APPENDIX G

Friends of the Bluffs Alternate Plan Sensitivity Analysis

SENSITIVITY TEST OF ALTERNATIVE PLAN FOR THE CENTRAL AND EAST SEGMENTS SUBMITTED BY THE FRIENDS OF THE BLUFFS

Figure 5-1 Friends of the Bluffs Alternative Plan.

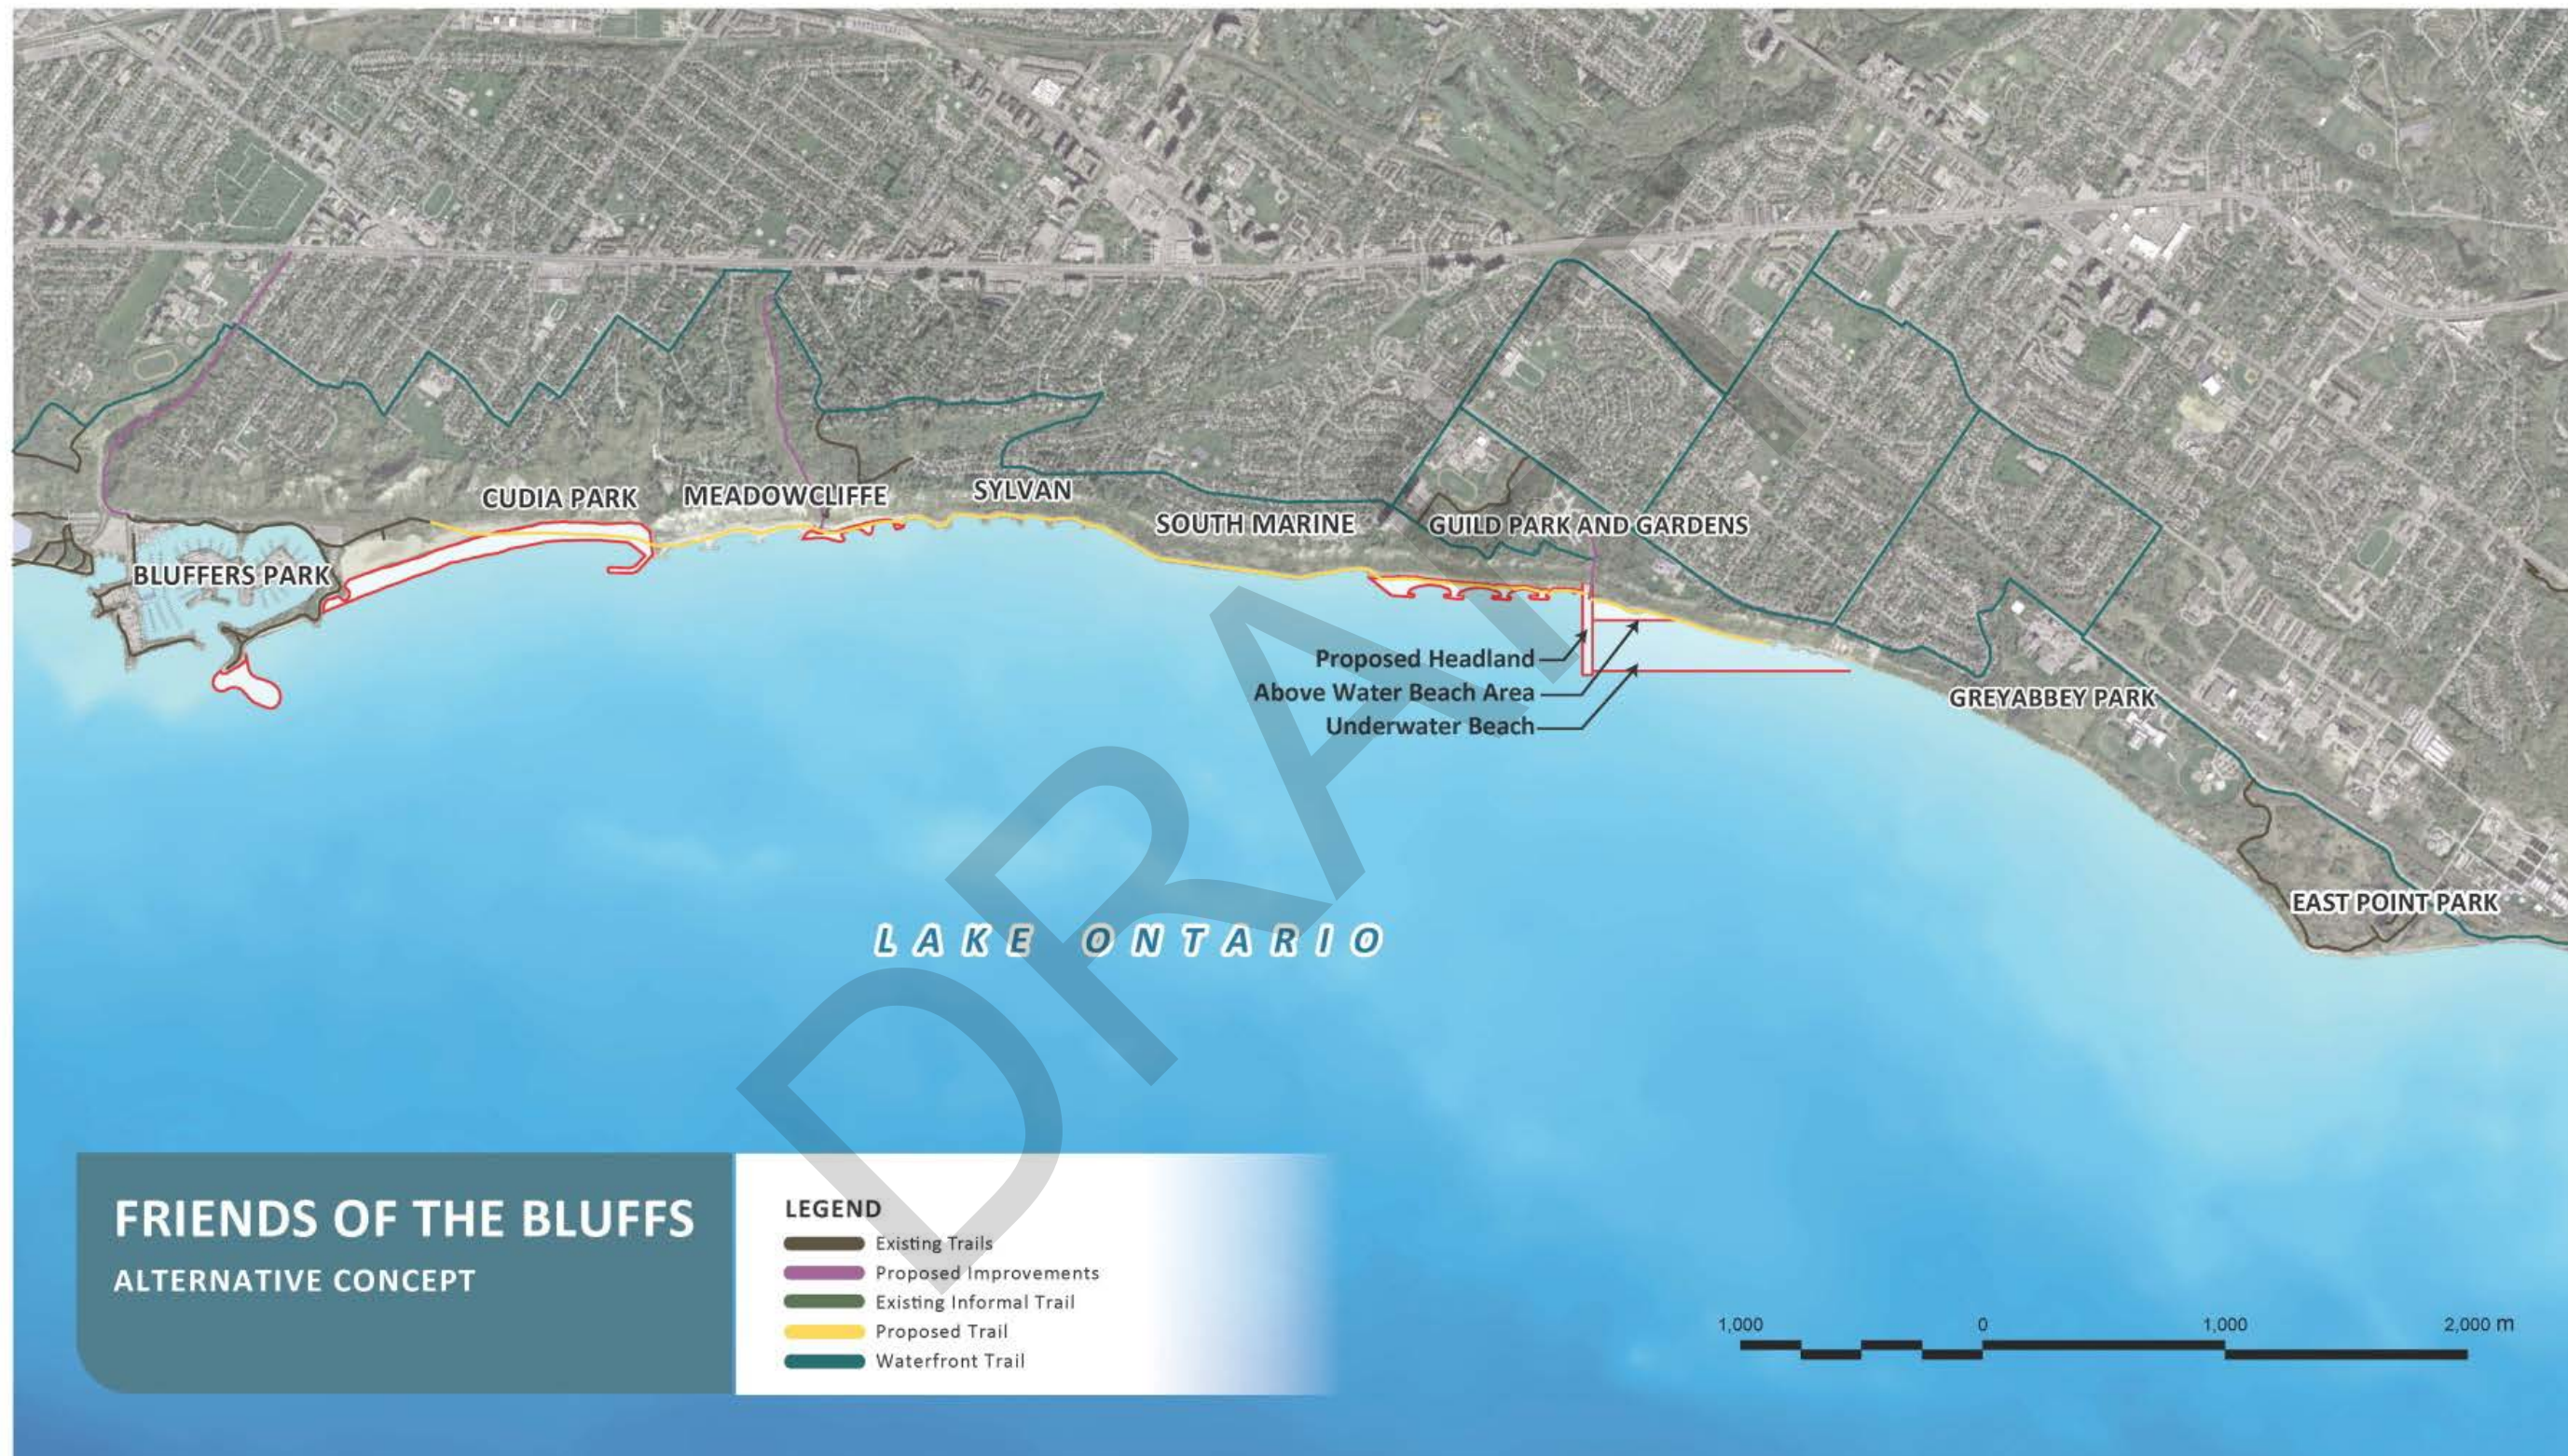
Given the public interest in this plan, TRCA undertook a sensitivity analysis which evaluated the Alternate Plan using the Objectives, Criteria and Indicators used to select the Preferred Alternative. The Alternate Plan submitted is at a coarse level of detail; therefore, a number of assumptions had to be made in interpreting the plan. It is noted that changes to these assumptions could change the anticipated effects; however, the ability of the Alternate Plan to meet Project Objectives will not change, as these are independent of the scale of the effects. **Figure 5-26** depicts the Alternative Plan submitted by the Friends of the Bluffs.

- Based on the scale of the drawing, the proposed headland is assumed to be approximately 350 m in length.
- Based on the scale of the drawing, and a 350 m-long headland, the above water portion of the beach, under typical summer water level conditions, would extend approximately 300 m east of the proposed headland, in front of an existing revetment. The underwater toe of the beach, retained by the new headland structure, would extend to approximately Morningside Avenue. It is expected that the underwater beach buildup would assist in stabilization of the existing shoreline works directly behind the beach; however, it is not anticipated to provide notable contributions to stabilization along the toe of the bluff east of the existing protection works.

It is noted from the above evaluation that the Alternate Plan fails to achieve a number of the Project Objectives.

- The Alternate Plan does not provide for the decommissioning of informal trails currently damaging vegetation communities on the tablelands and bluff slopes within East Point Park. In fact, the Alternate Plan has the potential to make this situation worse as it does not provide access to the shore between the Guild Park and Gardens and Beechgrove Drive, a distance of ~3.7 km. Managed formal public access to the shoreline helps to prevent informal trails which are contributing to the loss of native vegetation, habitat fragmentation, displacement of fauna, soil compaction and resultant erosion, altered hydrology, and the spread of invasive species.
- The Alternate Plan does not provide comparable opportunities to improve aquatic habitat along the shoreline through the creation of a more diverse shoreline below Grey Abbey Ravine and east to East Point Park.

- Recreational users along the existing sandy shoreline at East Point Park will be within the risk line for slope failure, and as such use of this area will be at their assumed risk.
- Greyabbey Trail (road and associated infrastructure) at the western end of Grey Abbey Park will be at risk from erosion within 60 years.
- EMS access to the shoreline between the Guild Park and Gardens and Beechgrove Drive will not be improved.

- The Alternate Plan may result in the loss or displacement of the existing Waterfront Trail between Greyabbey Trail and Beechgrove Drive, as the Metrolinx rail expansion will constrain the existing on-road connection through an increasing train frequency to every seven minutes, and potentially make the resulting off-road connection very narrow and unsafe.
- The new beach proposed at the base of the Guild Park and Gardens will be attractive to users but there will be limited opportunities to access the area as trail improvements are impossible without significant impacts to vegetation communities of concern and private properties. The creation of a beach without appropriate access will likely result in users parking on residential streets and seeking informal or trespass access down the slope of the Bluffs potentially causing greater environmental damage to sensitive bluff communities.

- Achieving Blue Flag beach status requires that a number of criteria be met including the provision of washrooms and parking which cannot be achieved at the base of the Guild Park and Gardens, given the access issues.
- The creation of a long headland to achieve sand accumulation in the Central Segment will preclude the accumulation of sand at Bluffer's Park Beach, so the Preferred Alternative for the West Segment, wide beach, cannot be achieved. There is the potential to fill the beach in the Alternate Plan through purchased material, such that sand will reach Bluffer's Park; however, this is a very expensive option.

- The Alternate Plan has the potential to create significant problems for adjacent residential properties either with respect to loss of the public infrastructure due to erosion, parking problems associated with access, and increased use of the Waterfront Trail within residential areas.
- The Alternate Plan does not consider the projected population increase in the City of Toronto (32% increase over the next 25 years) or the resultant pressure of increased use on greenspace.
